SAN FRANCISCO PLANNING DEPARTMENT

Discretionary Review Full Analysis HEARING DATE MARCH 9, 2017

Date: March 2, 2017
Case No.: 2016-005252DRP
Project Address: 2783K DIAMOND STREET
Permit Application: 2016.0413.4699
Zoning: RH-2 (Residential House, Two-Family)
40-X Height and Bulk District
Block/Lot: 6742/027A
Project Sponsor: Troy Kashanipour
SIA Consulting Corp.
1256 Howard St.
San Francisco, CA 94103
Staff Contact: Chris Townes – (415) 558-6620
chris.townes@sfgov.org
Recommendation: **Do not take DR and approve the project as proposed.**

EXHIBIT A:
MASS REDUCTIONS PER RDT COMMENTS

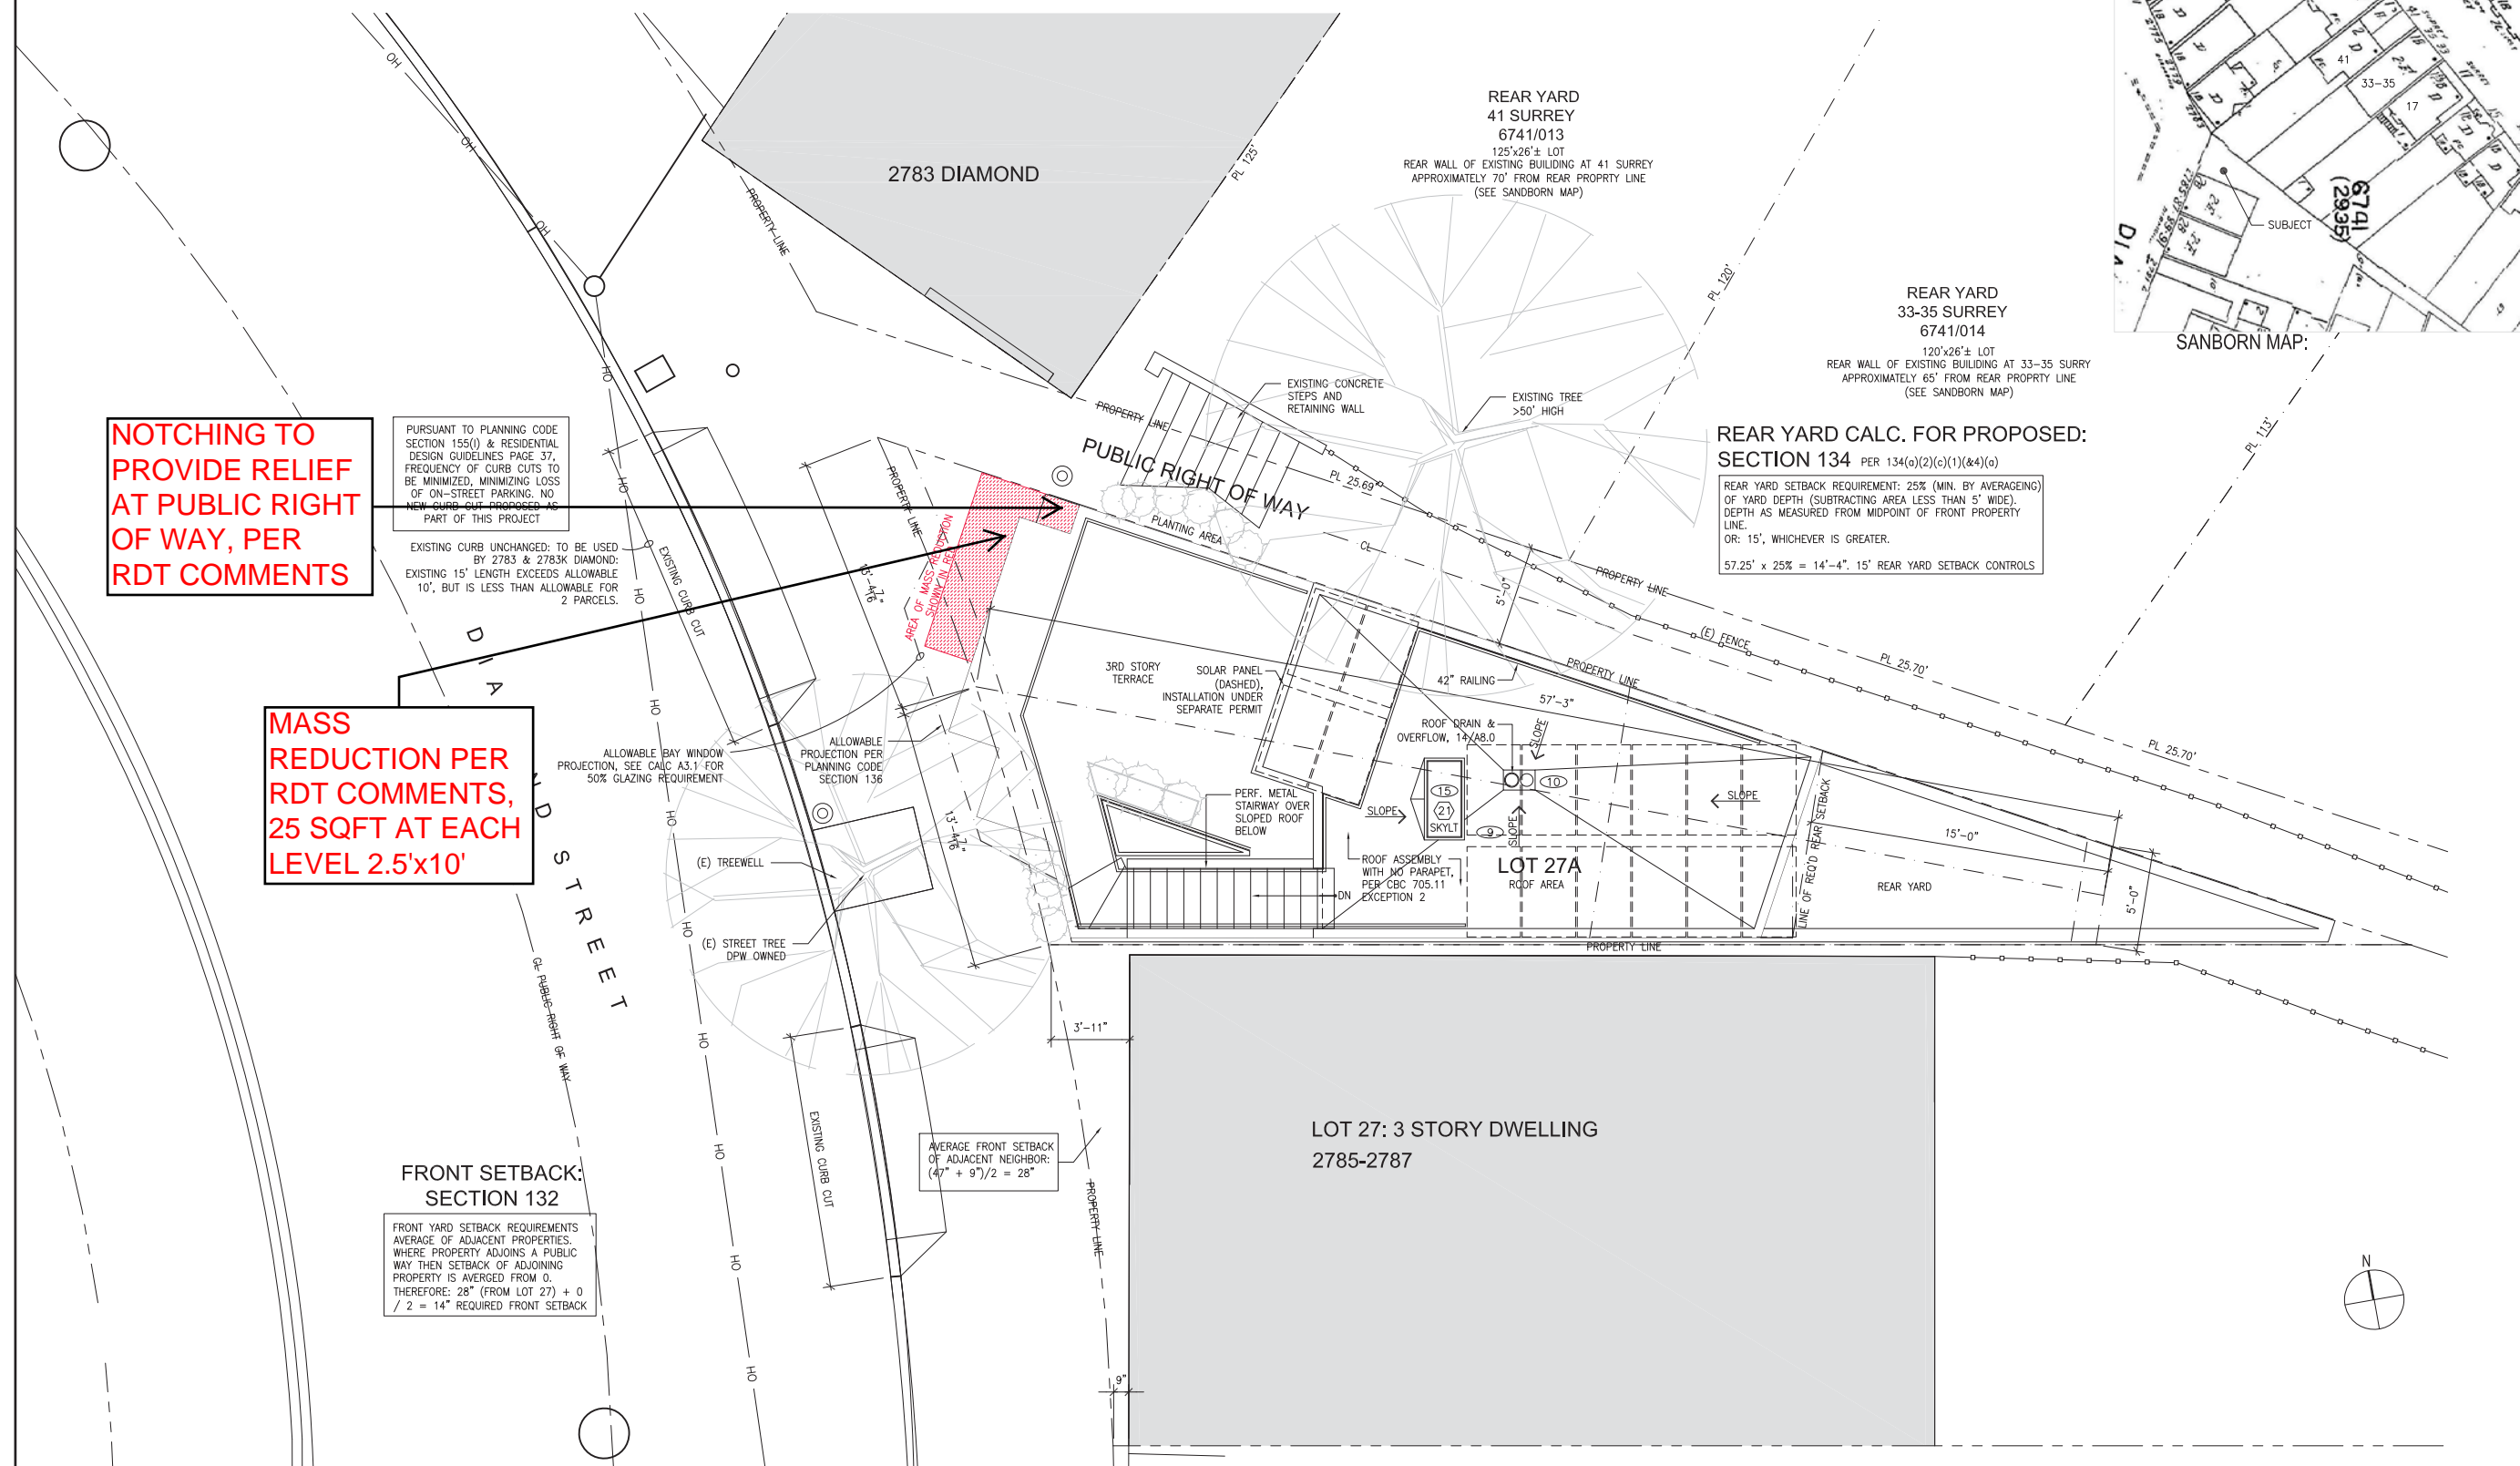
NOTHING TO
PROVIDE RELIEF
AT PUBLIC RIGHT
OF WAY, PER
RDT COMMENTS

A2.0

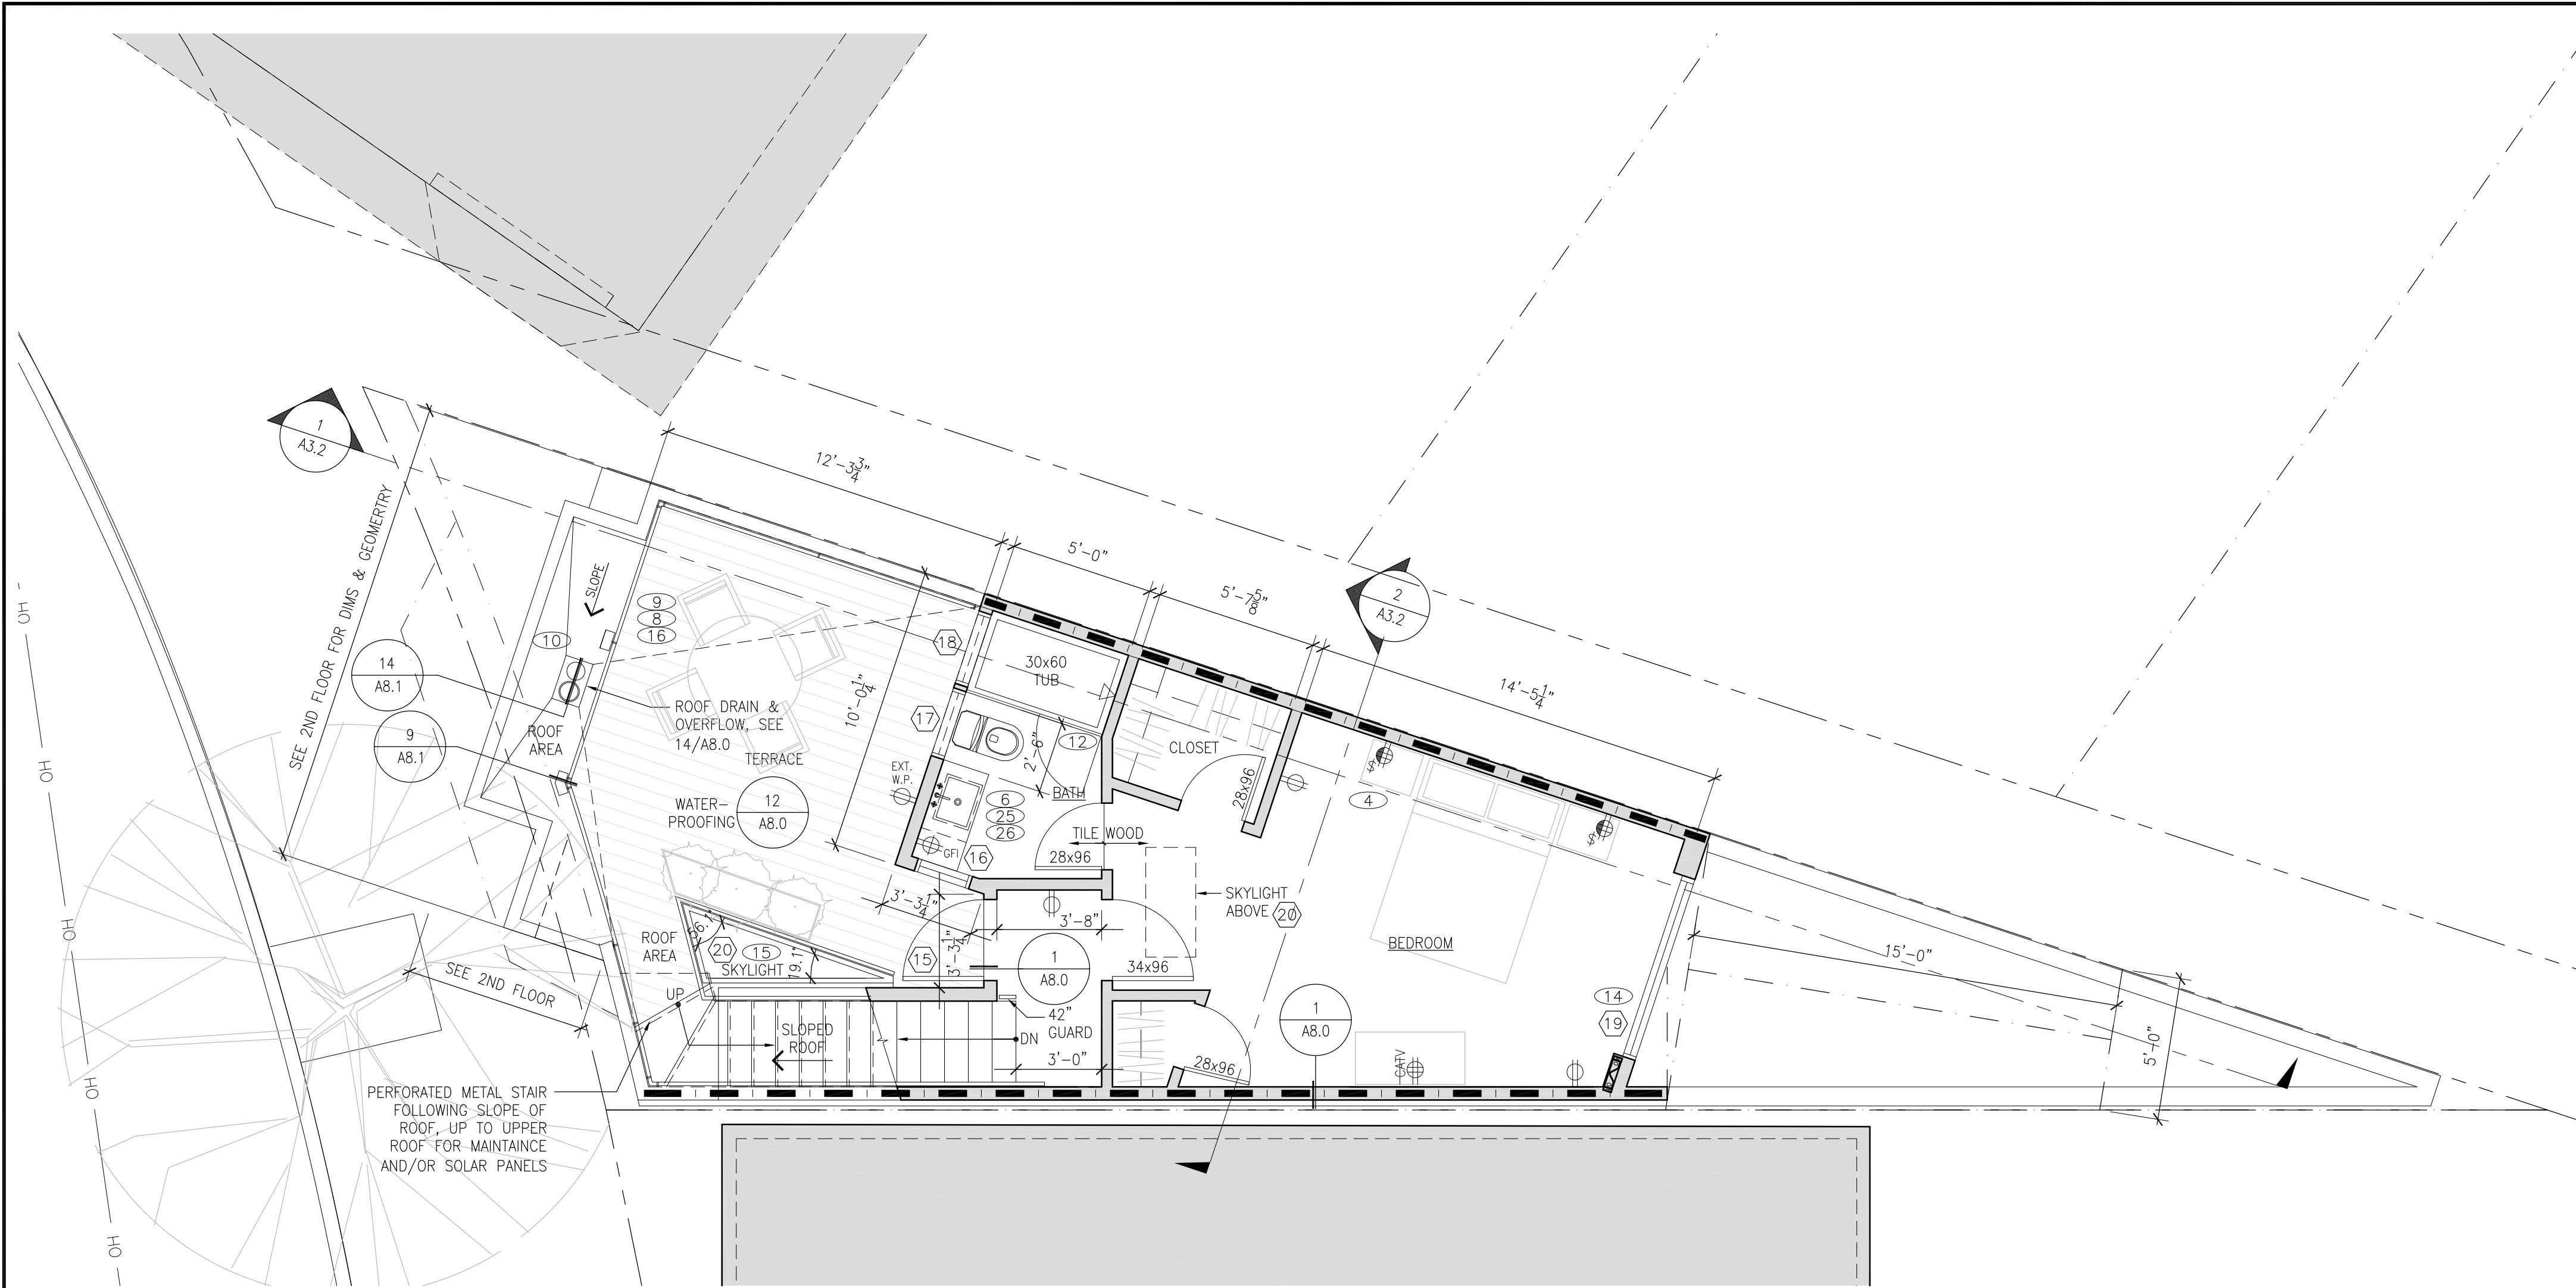
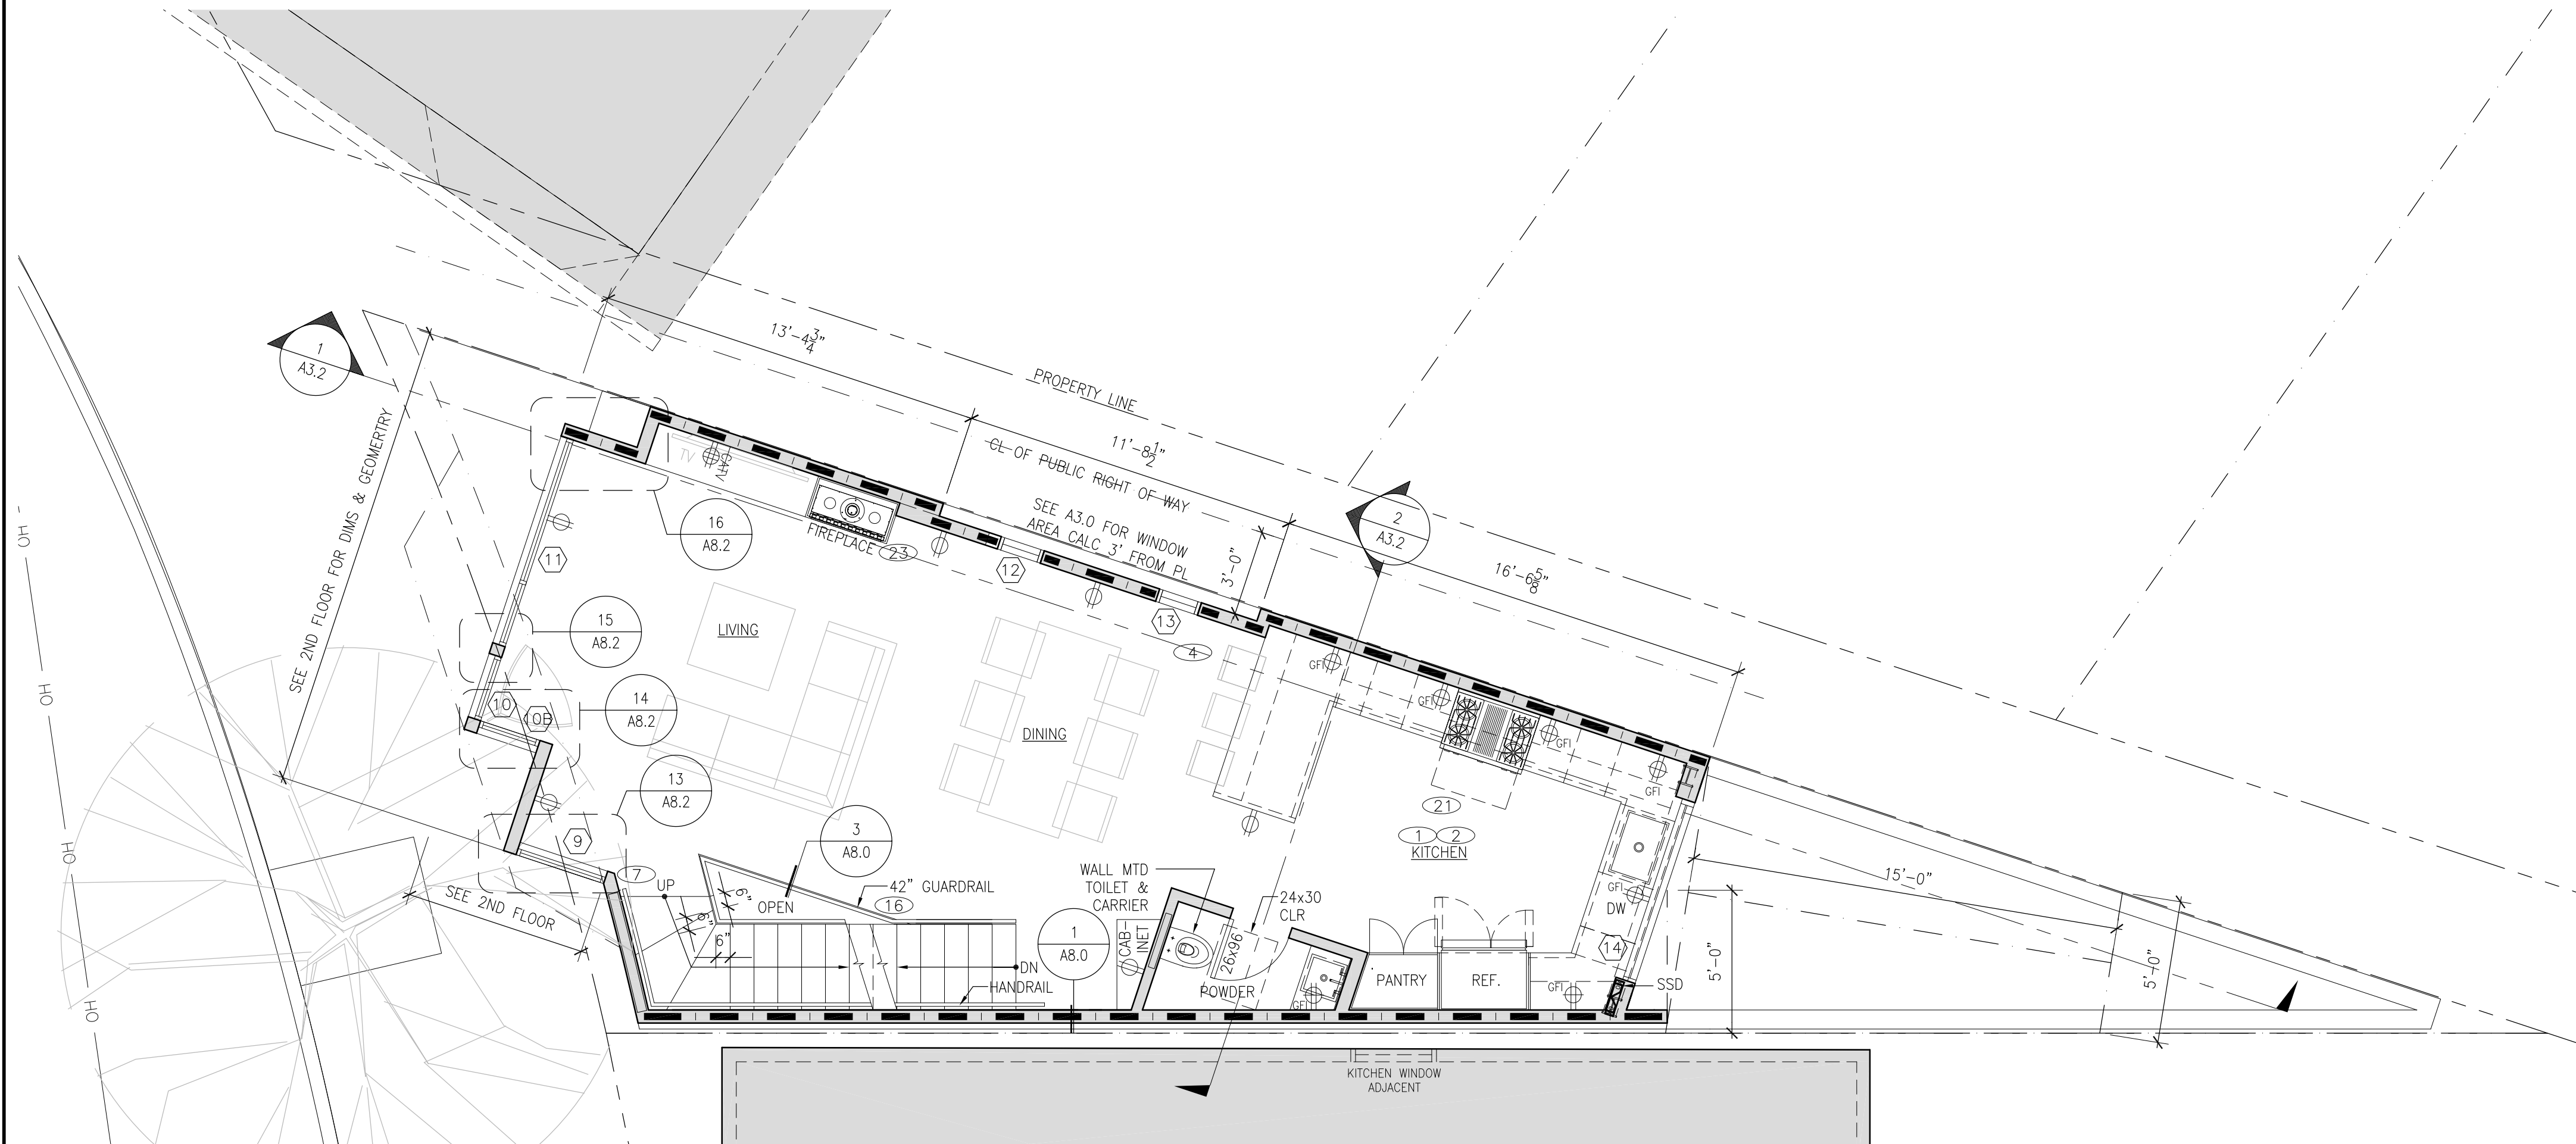
SUBJECT: Our Property Line is wrong on drawing A2.0.

The owner/architect of the 2783K property has submitted drawing A2.0 to the planning department that shows our Southern property line was moved 1 foot 2 inches North. The owner/architect has also moved the property and fence lines of my neighbors (properties 6741/13, 6741/14, etc.). This cannot be allowed.

It is my understanding that without the 1 foot 2 inches that Mr. Kashanipour has taken from my property on drawing A2.0 he submitted, his property line is infringing on, or in, the 5 foot Alley/Public Right of Way. The property owner of 2783K has changed the property lines of 2783 Diamond St, and properties 6741/13, 6741/14, etc. to his/her advantage and must be reviewed and corrected before permit approval.

Issue #2: The Department has researched the encroachment (into the 5-foot wide public right-of-way walk alley) claim by the concerned parties and has posed the issue to the original Survey authors for verification. The Survey company (Moran Engineering) who prepared the Survey, used as evidence of encroachment, for the nearby property located at Surrey Street, has confirmed in writing that their Survey was only intended to provide accuracy for that property (41 Surrey Street) and does not provide accuracy for any off-site property lines or public right-of-way boundaries. The Surveyor (with American Baseline Company) who prepared the Survey for the proposed project located at 2783K Diamond Street has confirmed in writing that their Survey of 2783K Diamond Street accurately establishes the subject property lines, the placement and configuration of the adjacent public right-of-way walk alley along the north property line, the property lines and existing fence improvements of the properties across the shared walk alley. Given the assurance provided in writing by the relevant Surveyors and their respective companies involved, the Department does not have any evidence of a valid discrepancy concern.
